STATE OF FLORIDA
DEPARTMENT OF HEALTH
ONSITE SEWAGE TREATMENT AND DISPOSAL
SYSTEM
APPLICATION FOR CONSTRUCTION PERMIT

☐ New System ☒ Existing System ☐ Holding Tank ☐ Innovative
☐ Repair ☐ Abandonment ☐ Temporary ☒ Modification

PROPERTY ADDRESS: 756 Pleasant Ter. Ft. white, Fl. 32038

Permit Application Number 20-0518

PART II - SITE PLAN 1" = 100'

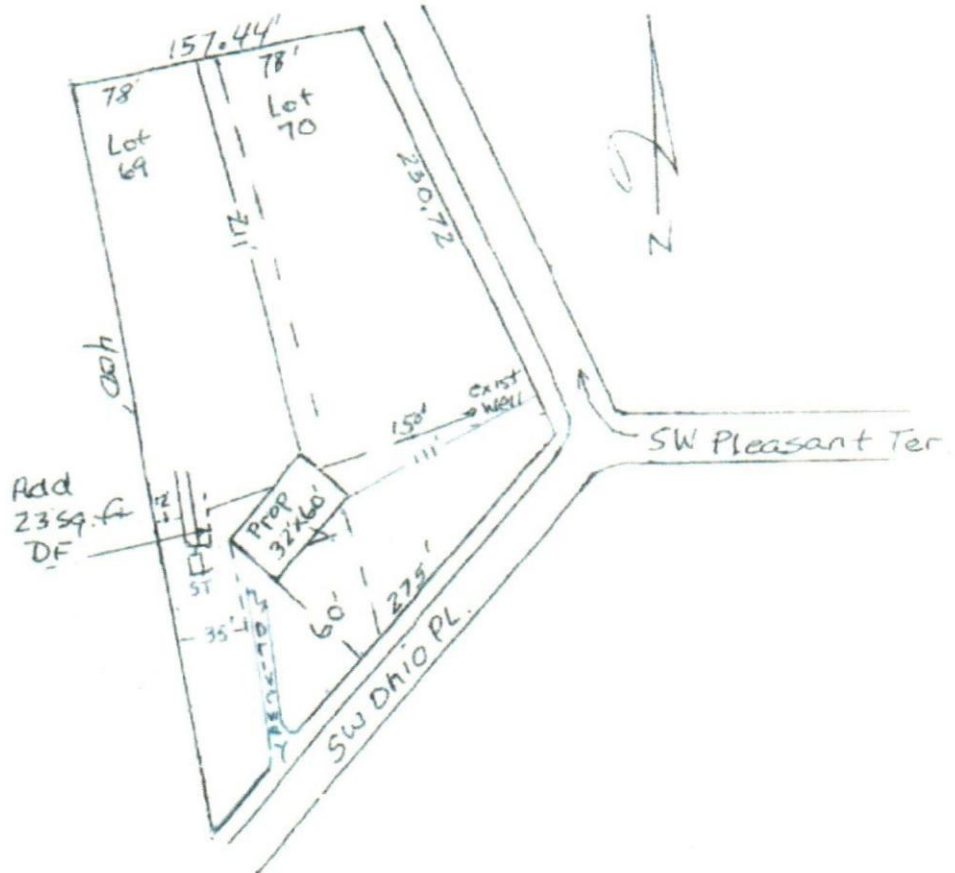
Notes: Modify DF to accommodate a 2 bedroom sized home. No pertinent offsite features.

Has 227 sq. ft. needs 250 sq. ft minimum - Needs 375 minimum 148 SQ FT addition

Plan Approved ☒
